London 2012 Olympic Park

Follow-on Project (Stage 2) Consolidated Validation Report – Planning Delivery Zone 1

December 2012

- Appendix A: Glossary of Terms and Definitions
- Appendix B: Schedule of Key Documentation (including summary of contents)
- Appendix C: Key Parties
- Appendix D: Permit to Proceed Protocol (CD only)
- Appendix E: Supporting Information
- Appendix F: PPDT / Hyder Document Review Comments and Responses

Drawing Title
**Figure 5 Sub-Grade Levels
For Planning Delivery Zone 1**

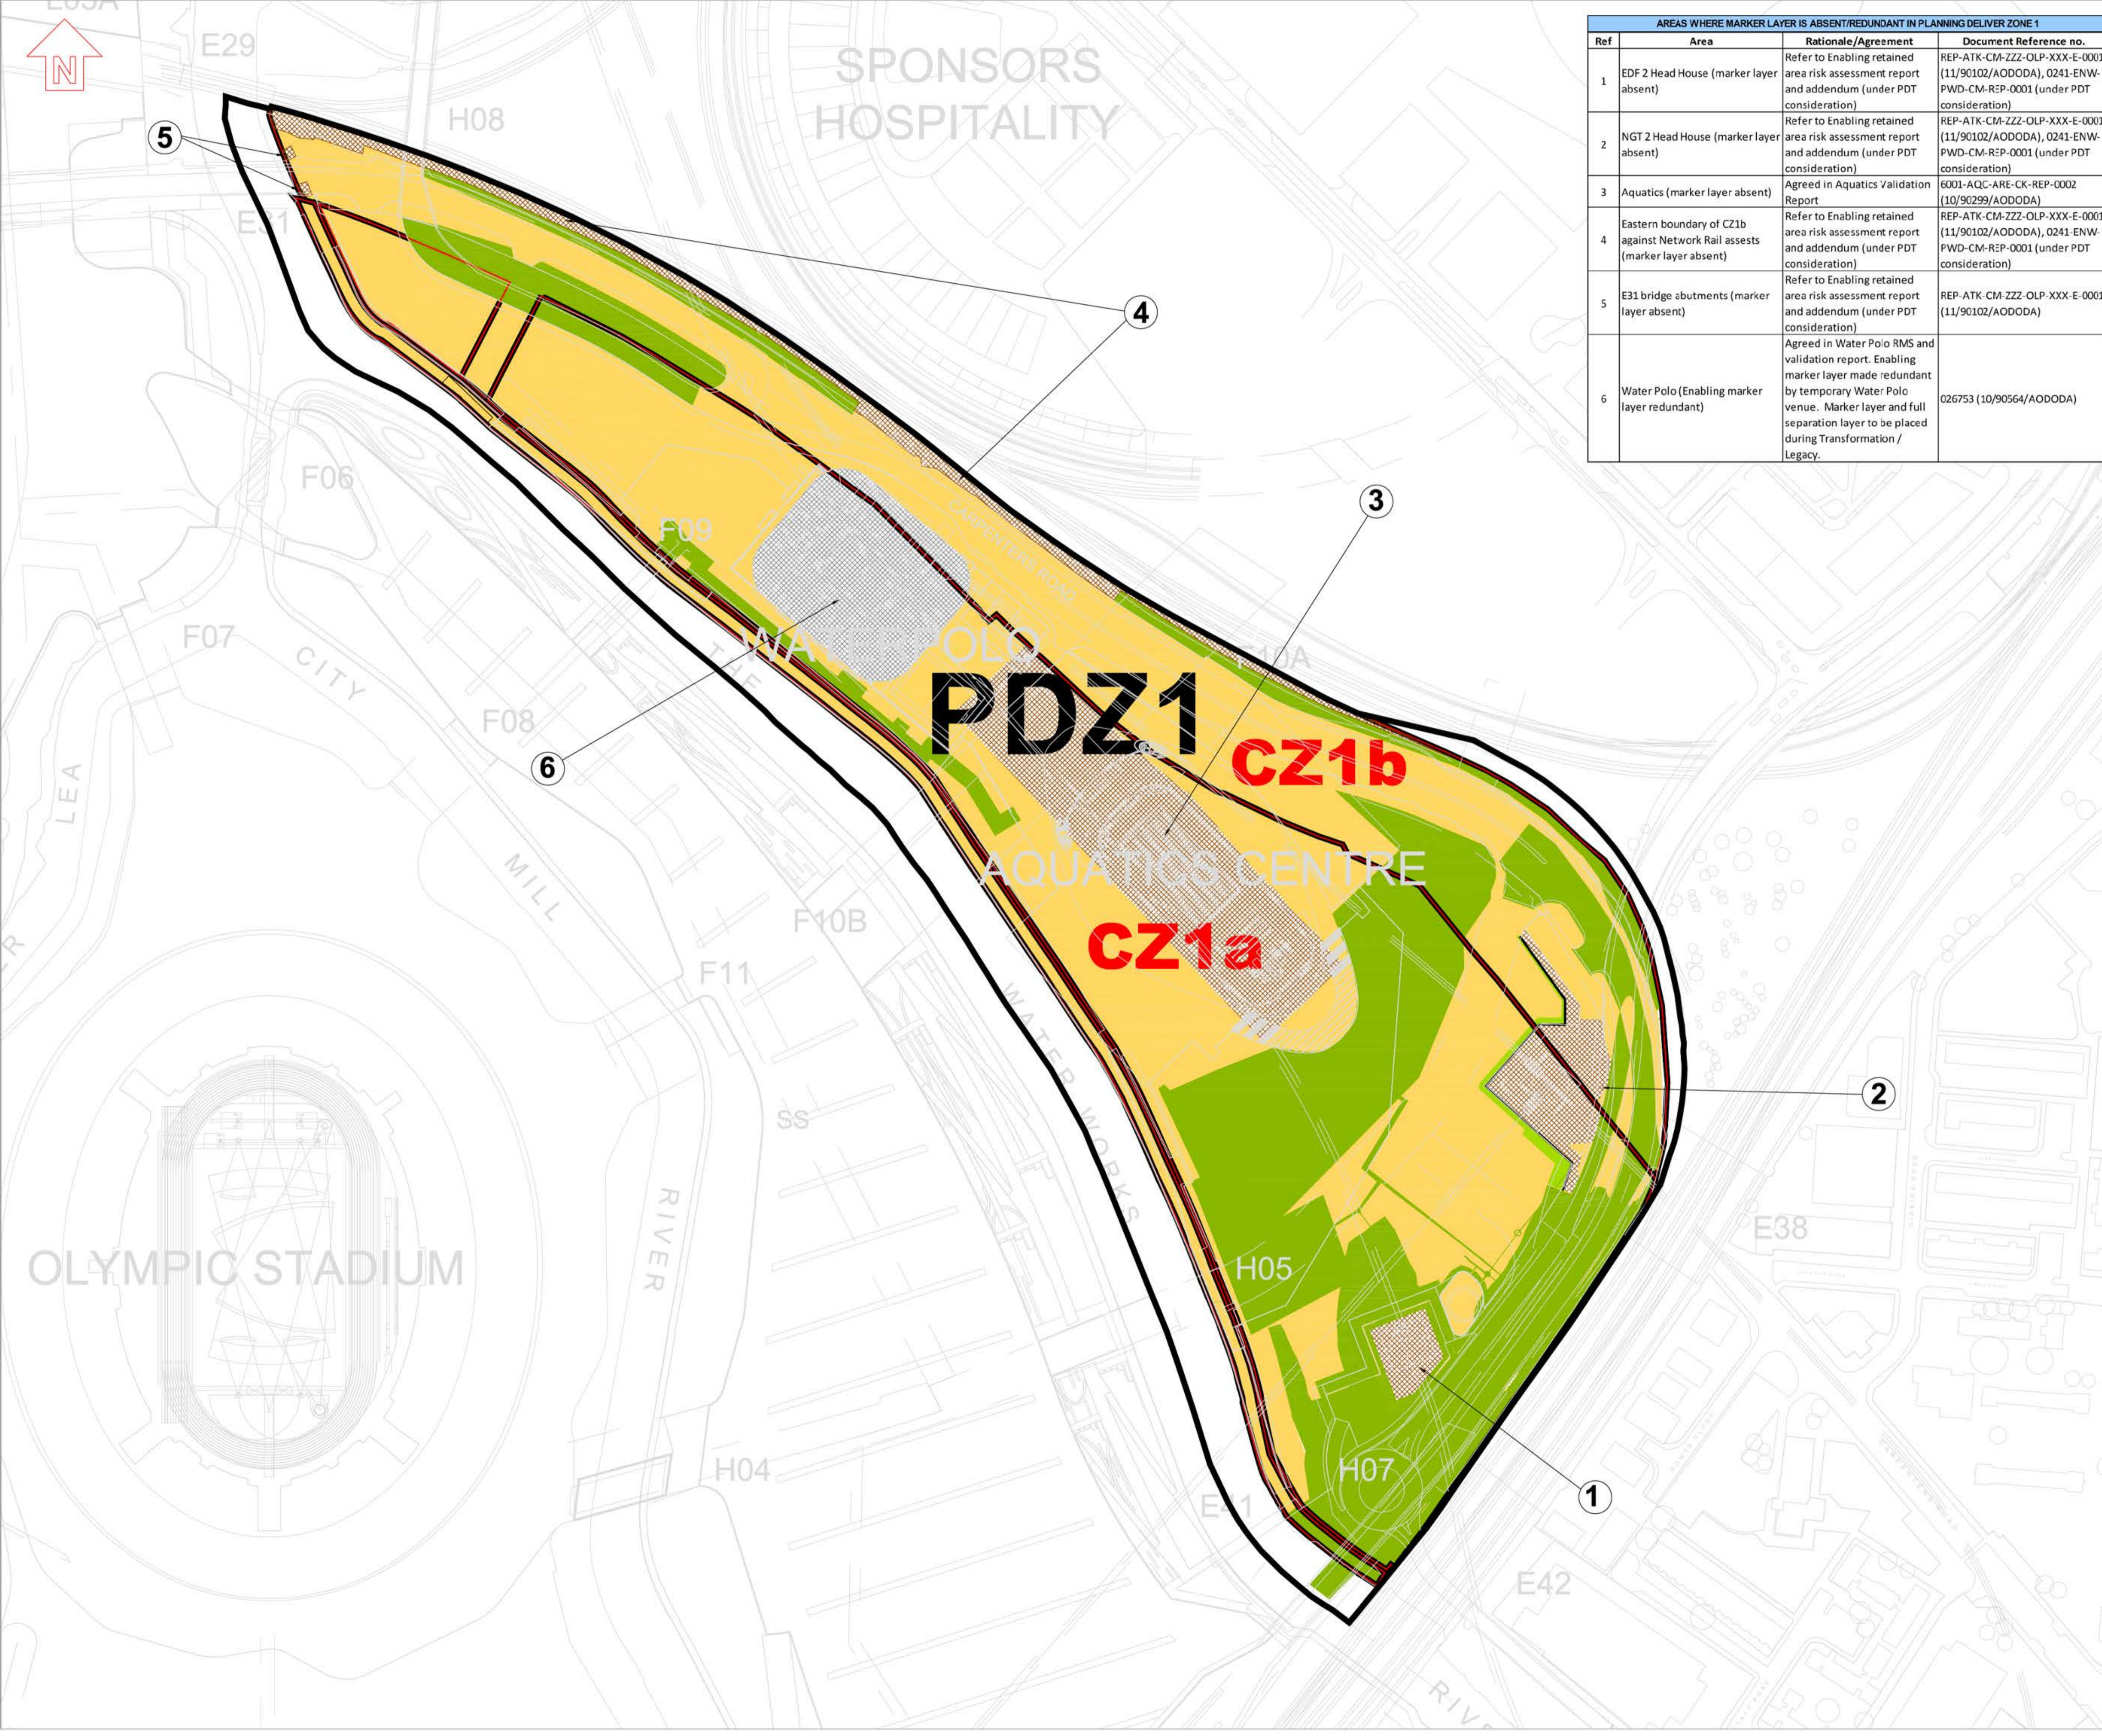
1.24	Figure 5 Sub-Grade Levels for Planning Delivery Zone 1	<p>Two legends are provided -</p> <p>8.935 Enabling Works sub grade levels (MAOD)</p> <p>8.935 FoP Sub grade levels (MAOD)</p> <p>However, it appears that four different colours (brown, mid green, lime green and purple) have been used in the drawing (extract below). Please could you confirm which are correct and update the drawing / legends accordingly. Further review may be required once updated.</p> 	<p>Response 03/12/12: The drawing colours have been amended so as to align with the legend notes and colours.</p> <p>Hyder 06/12/12: No further comment.</p>

Drawing Title
Figure 6: Extent of Marker Layer Within Planning Delivery Zone 1

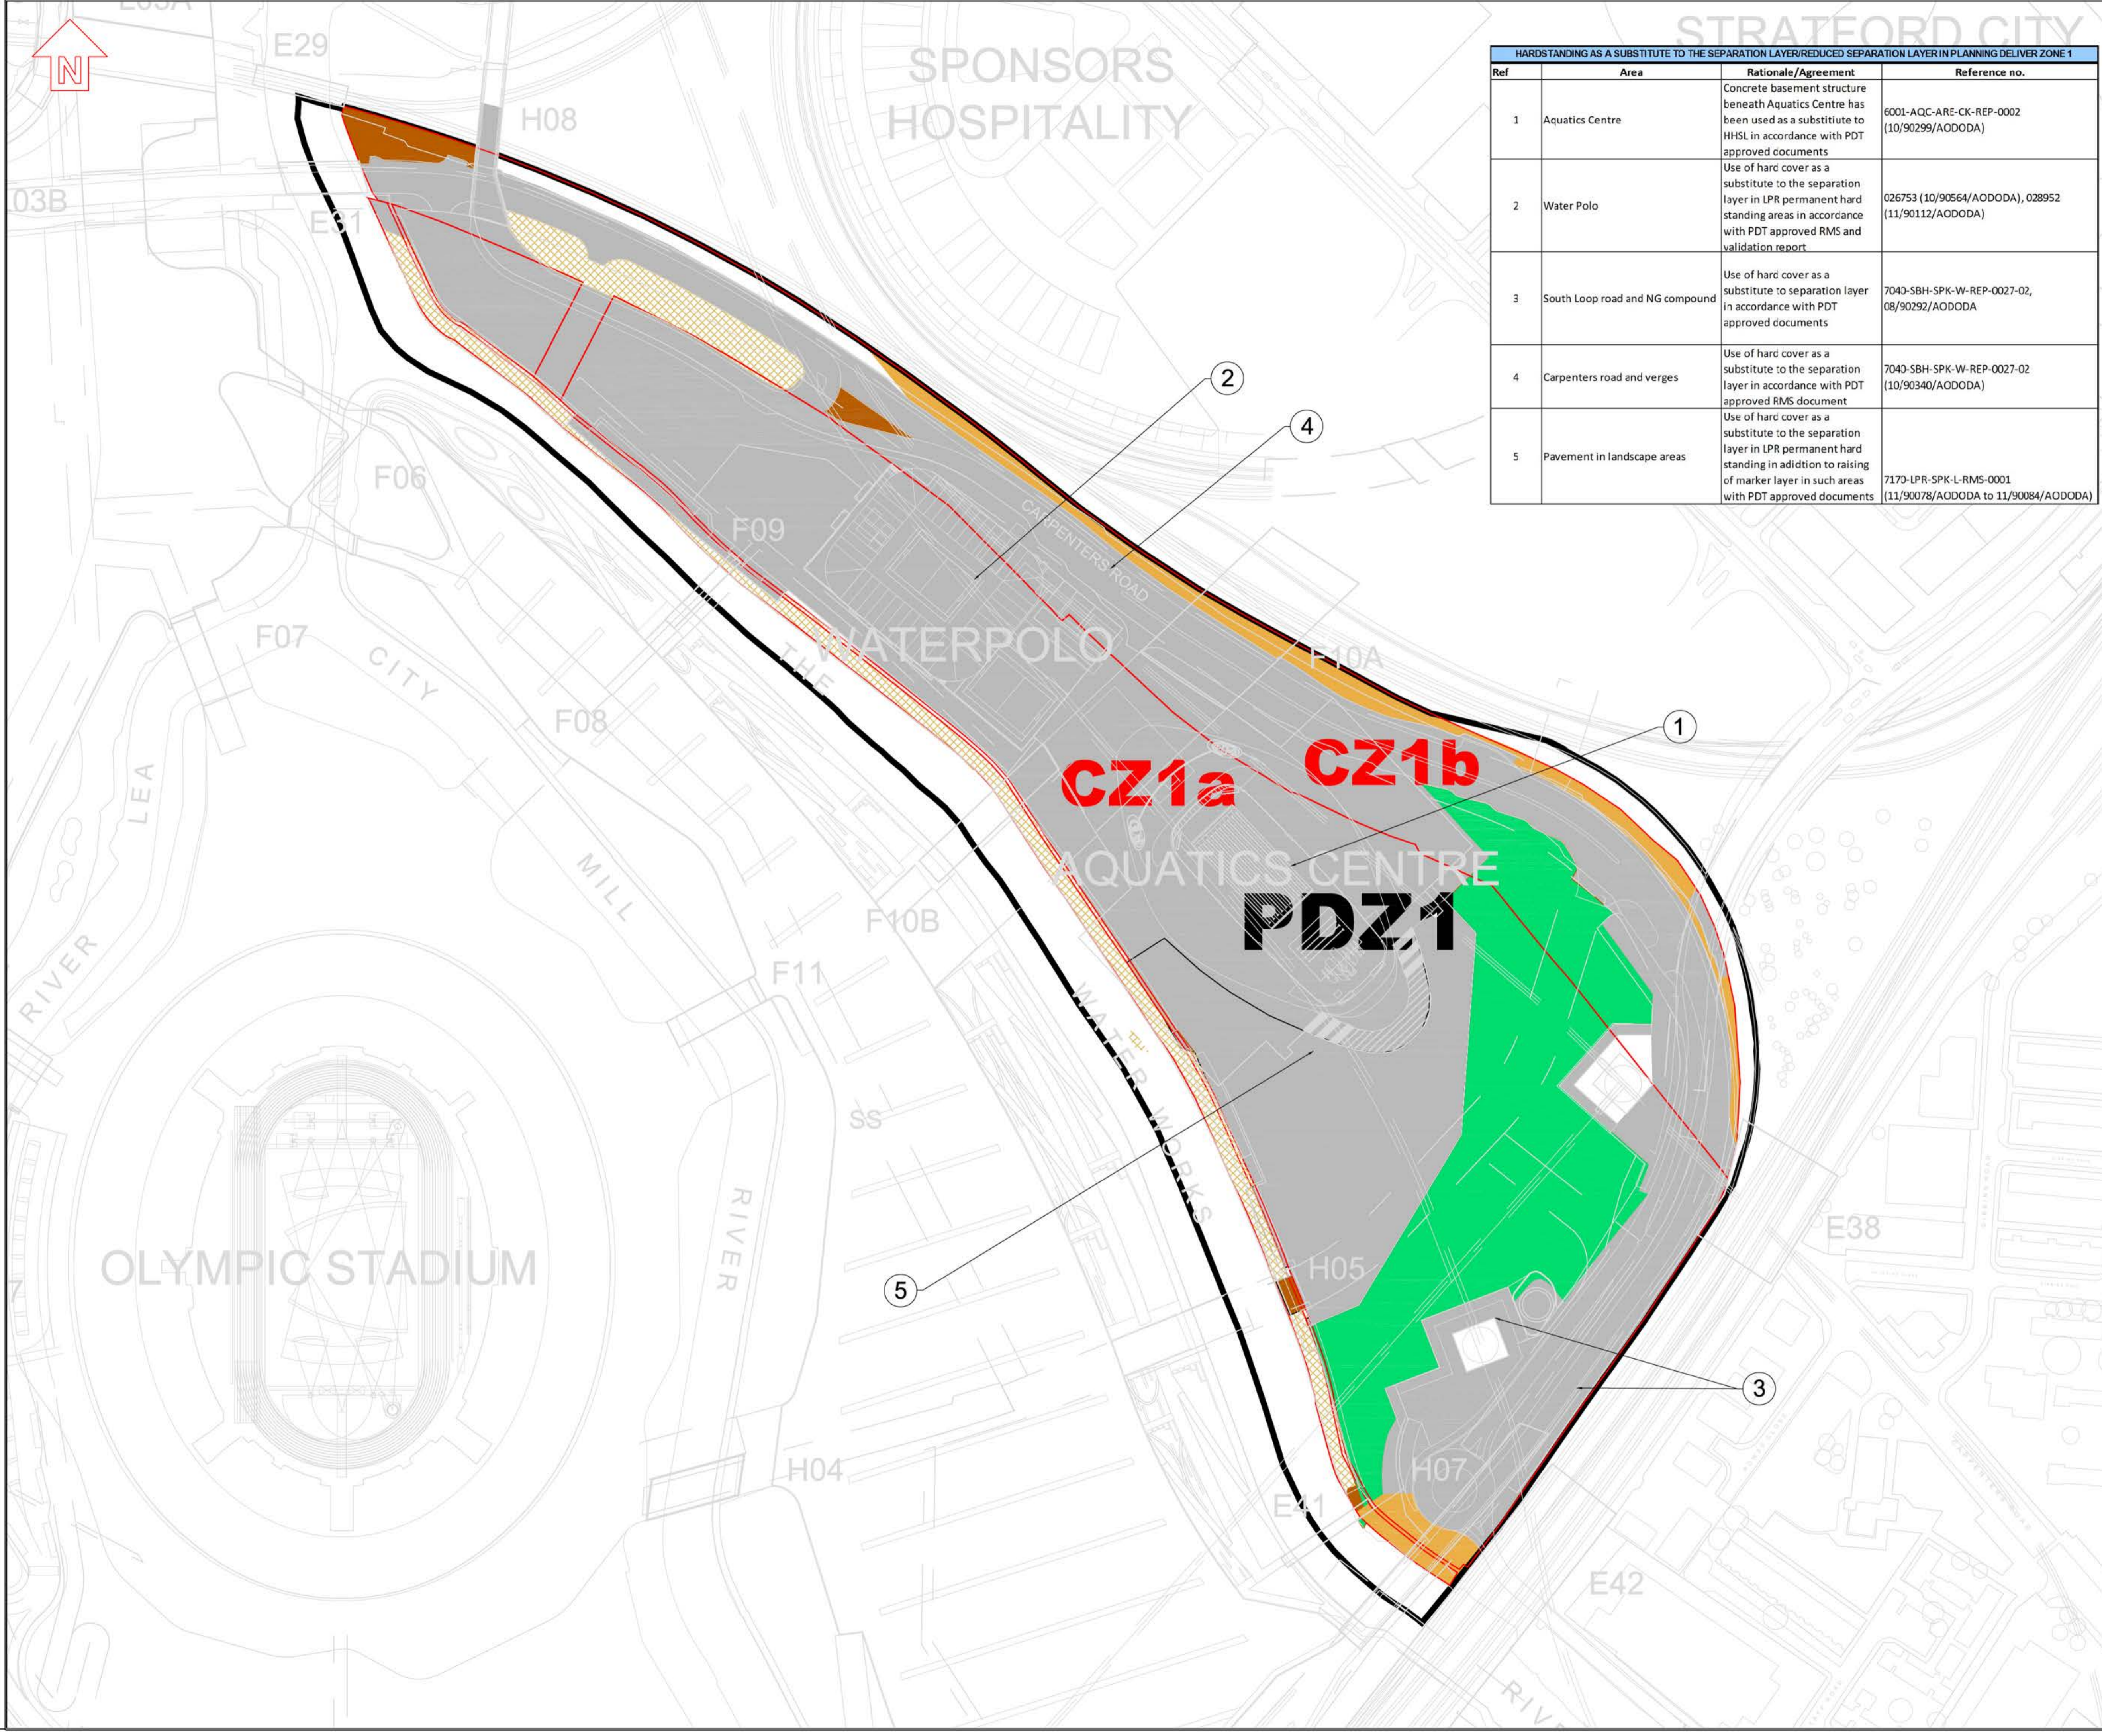
1.25	Figure 6 Extent of Marker Layer Within Planning Delivery Zone 1	<p>With regards to the arrows for Ref (1) and Ref (3), please could you confirm whether these are pointing to discrete locations, or discrete areas, this is currently not clear (extract below). The drawing may require updating accordingly.</p> 	<p>Response 03/12/12: The drawing has been amended to clarify these areas (now shown as one area). Note, the drawing Table refers to the RARA addendum as being 'under consideration'. If the status of this changes before this report is finalised this note will be updated.</p> <p>Hyder 06/12/12: No further comment.</p>

Drawing Title
Figure 7 Extent & Thickness of Human Health Separation Layer Within PDZ1

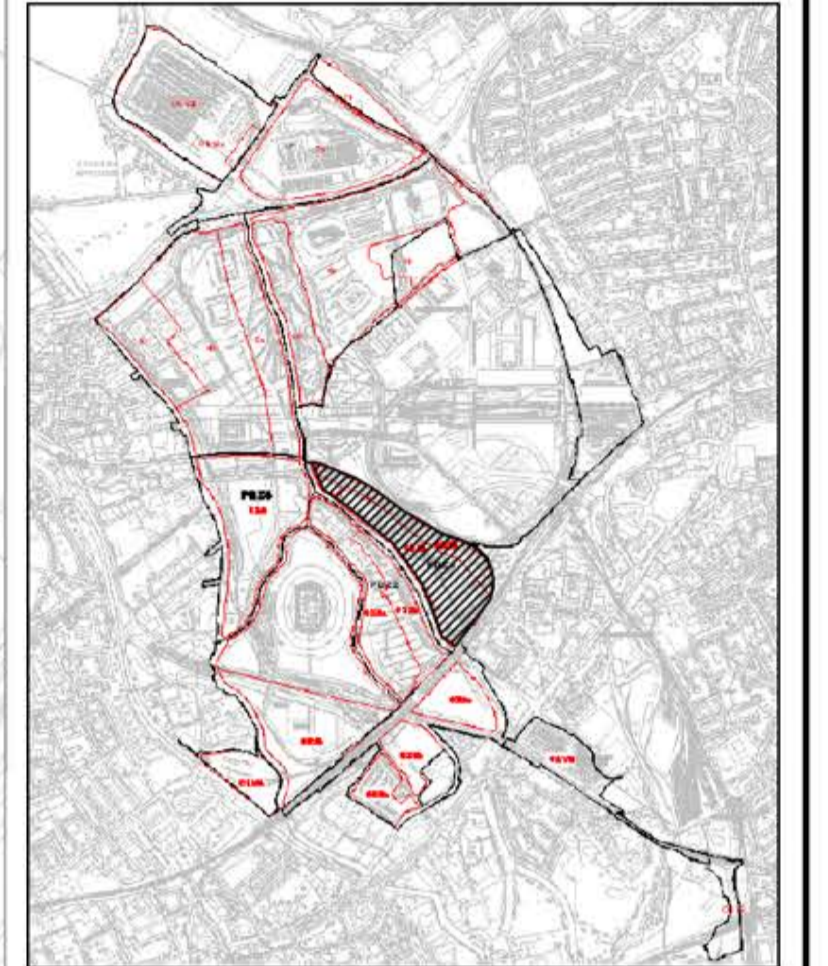
1.26	Figure 7 Extent and Thickness of HHSL Within PDZ1	The following extract is shown on the drawing: <u>Notes</u> Reference should be made to the stage 3 CVR to confirm where separation layer is to be completed by LOCOG. However, section 4 of the CVR states "Aside from the residual actions identified in Table 4.1 below, the ODA has completed the SSRS remedial scope within PDZ1 and is not reliant upon works by LOCOG to demonstrate the design has been fully implemented." Should the text on the drawing be removed? Or are there works that are reliant on LOCOG?	Response 03/12/12: This standard legend note has been removed and the drawing amended to show a section to the south east of the Aquatics Centre where LOCOG is to complete the hard standing surfacing. In addition the text within the report Conclusions (Section 4) has been amended to account for this residual action and an item added to Table 4.1. Hyder 06/12/12: No further comment.

1.27	Figure 7 Extent and Thickness of HHSL Within PDZ1	There are a number of "blank spaces" shown on this drawing – please could you confirm if these are intentionally white, and if so, a legend is required. If not, please could you update the drawing to remove the blank spaces.	Response 03/12/12: The drawing has been checked and there remain a couple of discrete areas where ODA FoPs have not completed validation. A legend note has been included to state these areas have not been subject to validation. Hyder 06/12/12: No further comment.

1.28	Figure 7 Extent and Thickness of HHSL Within PDZ1	Please ensure the reference number for the WaterPolo report is correct (shown as 028952 on drawing and 028925 in Appendix B).	Response 03/12/12: The reference on the drawing is correct and the Appendix B reference has been corrected. Hyder 06/12/12: No further comment.

1.29	Figure 7 Extent and Thickness of HHSL Within PDZ1	There appear to be many areas where HHSL is less than 600mm. Are these deficient areas covered by the residual remediation table and or explained in the individual FOP reports?	Response 03/12/12: Due to the extent of hard standing and the venues within PDZ1 there are extensive areas where the HHSL is less than 600mm. These areas are highlighted in the Table in Figure 7 and are as per the agreed RMS and individual FoP validation reports. Hyder 06/12/12: No further comment.
